2nd Land Use Review Response, Response to Public Comments Transportation

LU: 26-026160-000-00-LU Date: July 1, 2026
To: Andrew Gulizia, Portland Permitting & Development, B299/R5000
From: Tammy Boren-King, PP&D, Public Works- Transportation
503-823-2948, tammy.boren-king@portlandoregon.gov
Applicant: Portland Public Schools *Gabe Asch*
PORTLAND PUBLIC SCHOOLS
501 N DIXON ST
PORTLAND, OR 97227

Location: 1151 SW VERMONT ST

TYPE OF REQUEST: Type 3 procedure CU - Conditional Use

Public Access Easement
Diagram

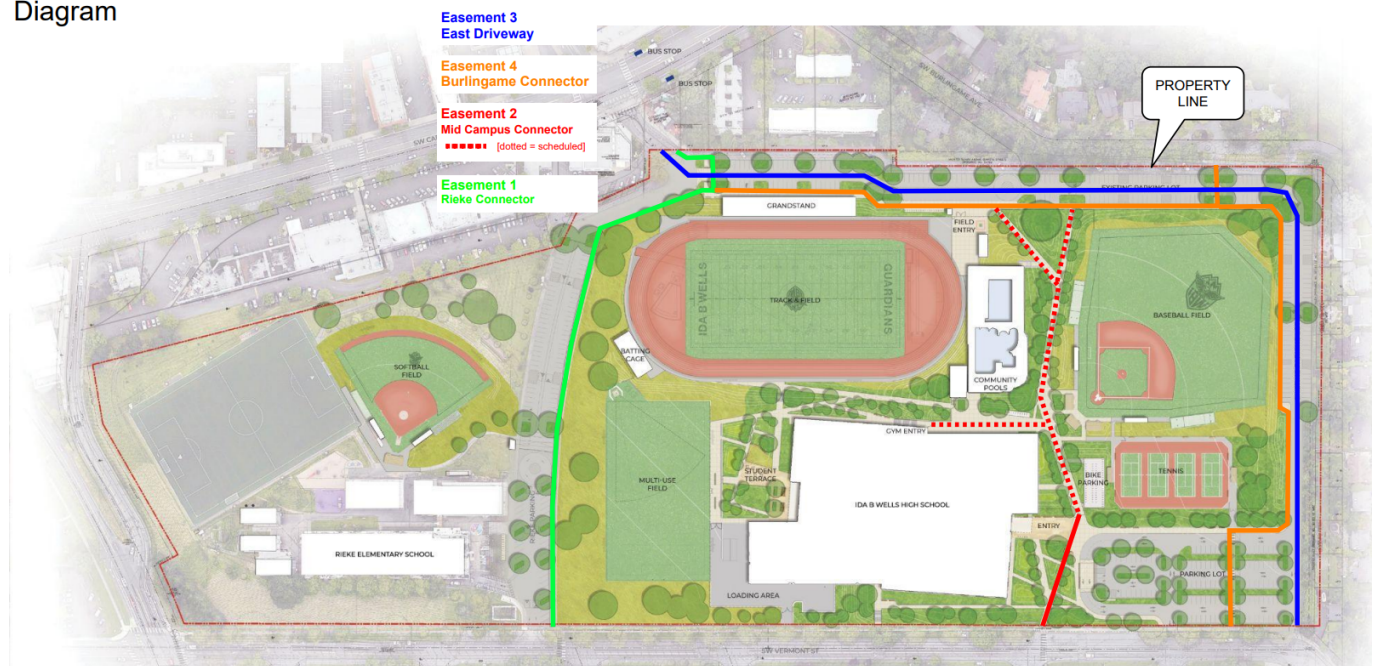
The image below is included in the access plan. Staff note the eastern route is shown in blue, not in the green described in the text above. The green shows the easement location proposed along the major public trail alignment.

In order to provide multi-modal access to meet the connectivity requirements, staff recommend modifying the recommended condition of approval to note that the public access easements granted through this project must allow bicycle access for mounted cyclists for routes outside of the fence line, including along the east side of the Rieke driveway or in the drive aisle for the Rieke driveway. This is the direct connection through the site. Requiring cyclists to walk the quarter mile distance while pushing their bikes does not meet the connectivity requirement for access for all modes. Staff note the alternate route available by diverting east on Vermont St. and circling the school is an approximately 3,200 feet of out of direction travel. This is over a half mile of additional travel that is an uphill climb the entire easterly leg of the journey on SW Vermont St. Staff believes the proposal as initially submitted showing bicycle access for mounted riders along the east side of the Rieke driveway connection meets the approval criteria. While not specifically proposed, allowing mounted riders to ride within the drive aisle would also meet the approval criteria. Any revised proposal that requires cyclists to dismount and walk or divert over a half mile out of direction does not meet the connectivity standards for this 35 acre site. Staff recommend the proposed condition of approval be modified to read as follows with the new text in bold:

The applicant shall submit the four public access easement agreements shown and described in the document titled “PPS Memo Access Plan Updated April 16, 2026”, included as Exhibit XXX, to the City of Portland with the school building permit application for review and approval by the City

Attorney. The public access easements must be executed and recorded prior to issuance of the building permit for the school building. The easement agreements will identify the post-construction effective date of public access as well as other essential terms, such as hours of operation and emergency closure restrictions, consistent with Exhibit XXX. **The public access easements granted through this project must allow bicycle access for mounted cyclists for routes outside of the fence line, including either the pathway on the east side of the Rieke driveway or in the drive aisle for the Rieke driveway.**
